SAN ANTONIO WATER SYSTEM
FAR WEST SEWER RELIEF MAIN (FW-01)

SAWS Job No. 09-2501
Solicitation No. B-11-052-RA

ADDENDUM NO. 2

October 04, 2011

1 PROPOSED SEWER RELIEF MAIN (AIR JUMPER)
 SCALE HORIZONTAL 1"=20', VERTICAL 1"=5'

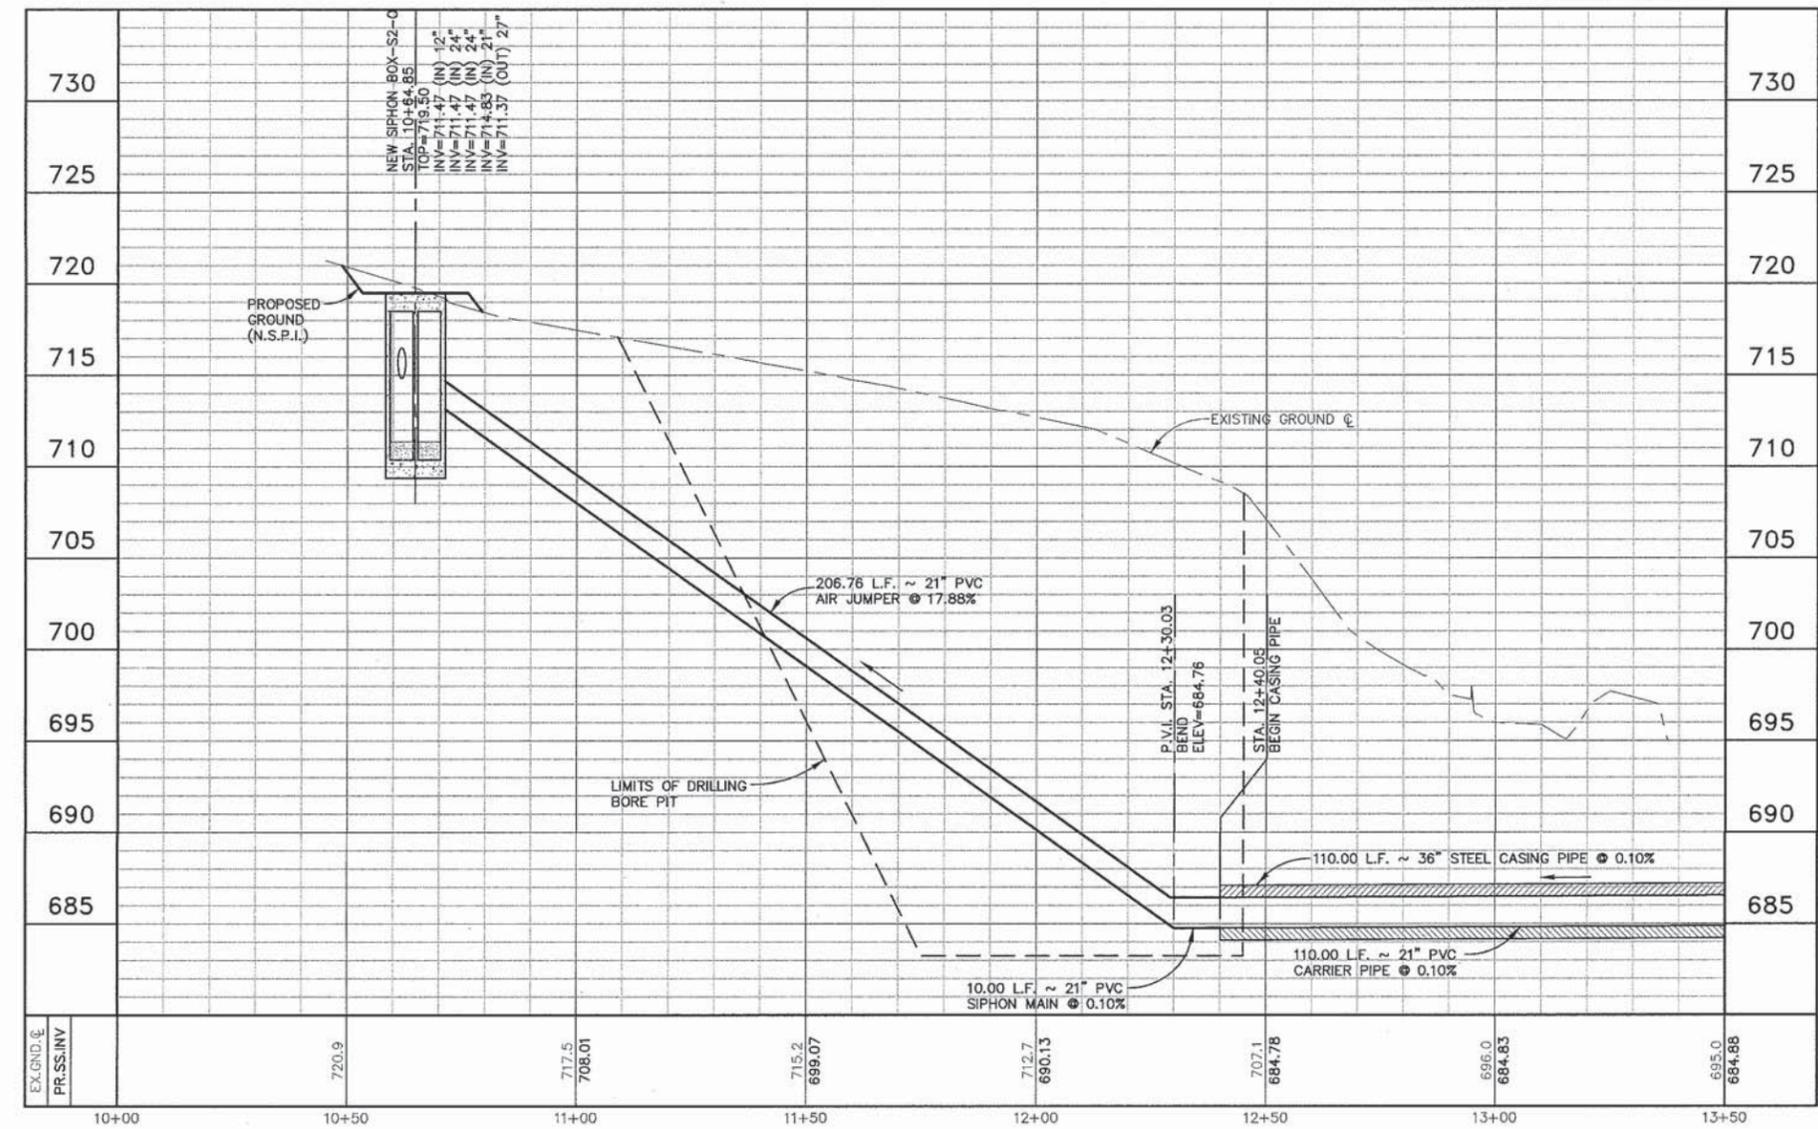
- Q2) Bid item 848, 20" PVC Sewer Pipe is not made in SDR26 in that size could that line be up size to 21" or down size to 18"? If the 20" line is required, what other pipe would be considered.

- A2) The 20" PVC Air Jumper Pipe shown on pages 3-5, 7-12, 17-20, 24, and 28 will be changed to a 21" PVC pipe. Sheets 3-5, 7-12, 17-20, 24, and 28 are hereby re-issued to reflect this change.

MAP No. 104-566, 106-566, 108-568, 108-570 SHEET 22
 SECT. No. OF 48
 DR. TM CK. HMC JOB No. 09-2501

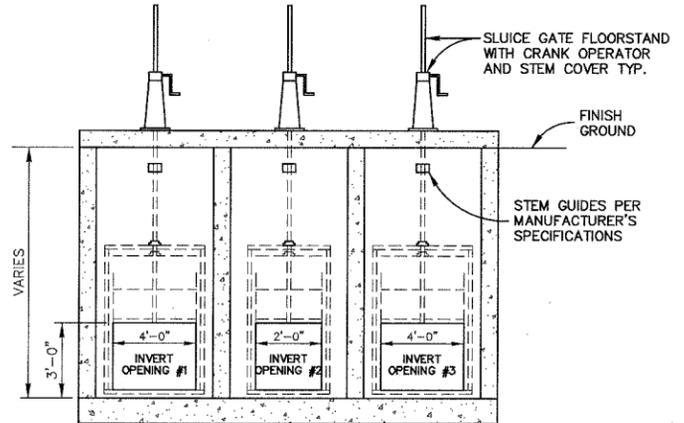
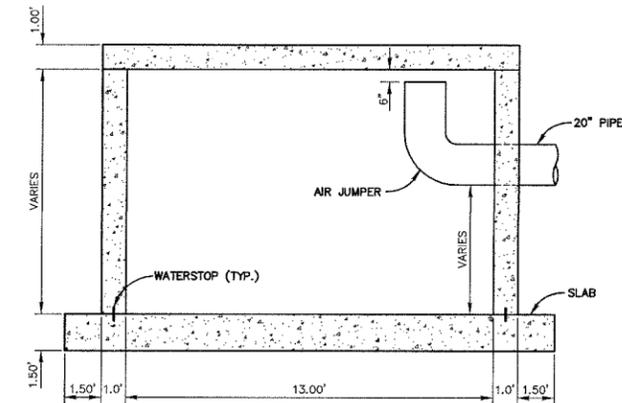
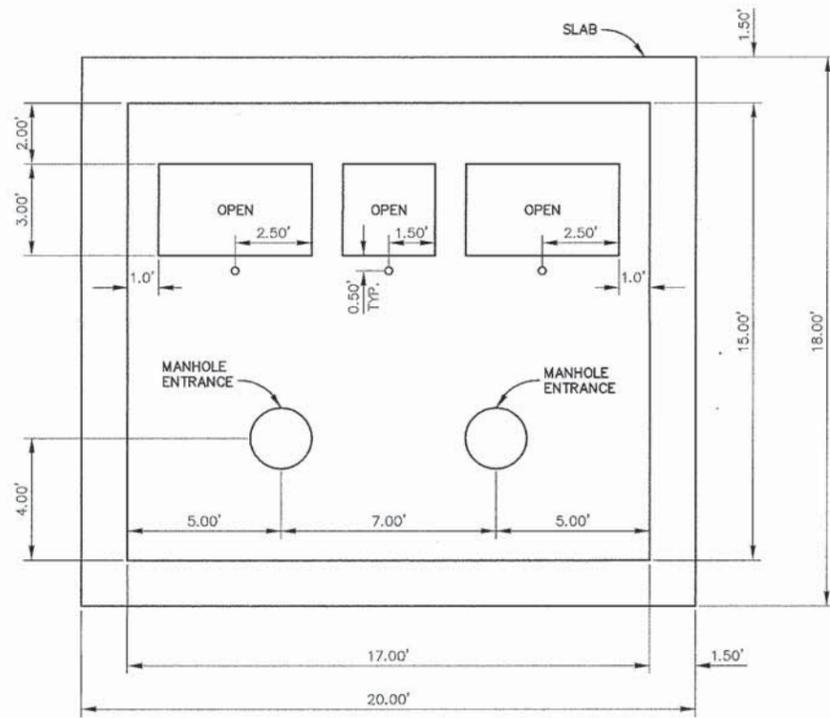
- Q12) We have review the drawings and specs both myself and Whipps, the gate manufacturer and we do not seem to seem to find the schedule. We need to know the head that would be applied to each of the gates to make sure that we have the right frames and seals for them.

- A12) The gate schedule is shown on sheet 22 of 48 in the attached revised plans.

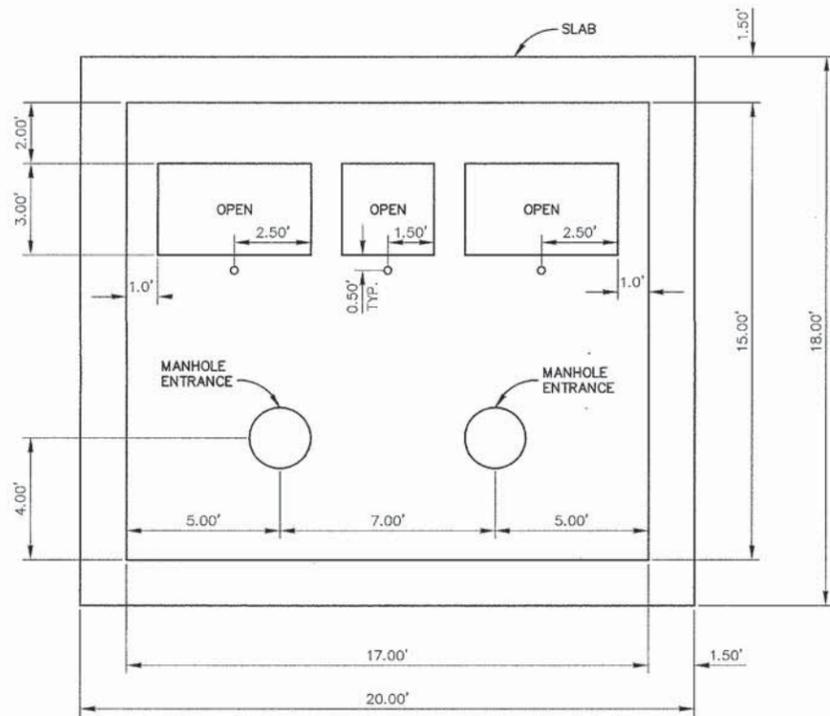
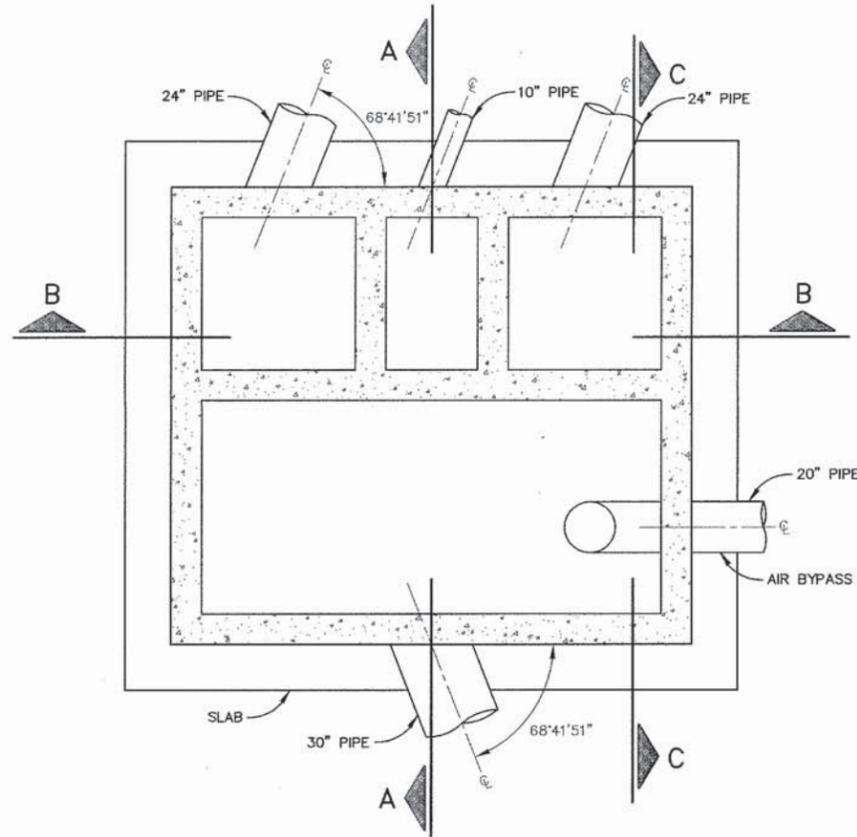
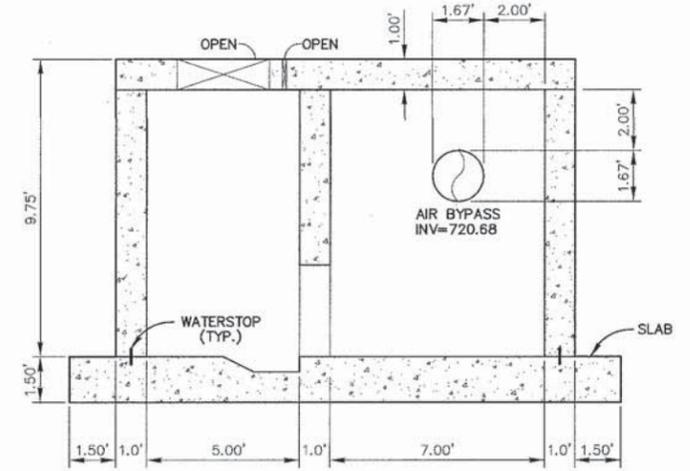
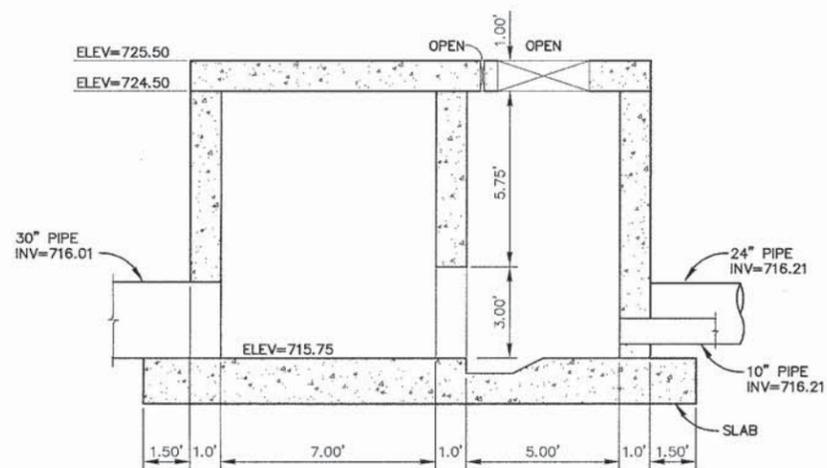
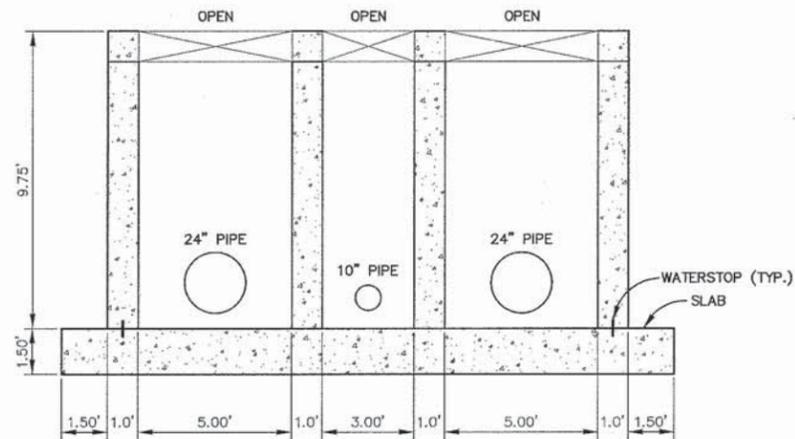
- Q11) On sheets 24, 28 and 30 there is a discrepancy on the height of the boxes from section B-B and C-C. Which height is correct?
- A11) On sheet 24 the correct box height is shown on Section B-B (11 feet), on sheet 28 the correct box height is shown on Section C-C (9.75 feet), and on sheet 30 the correct height is shown on Section B-B (8.25 feet).
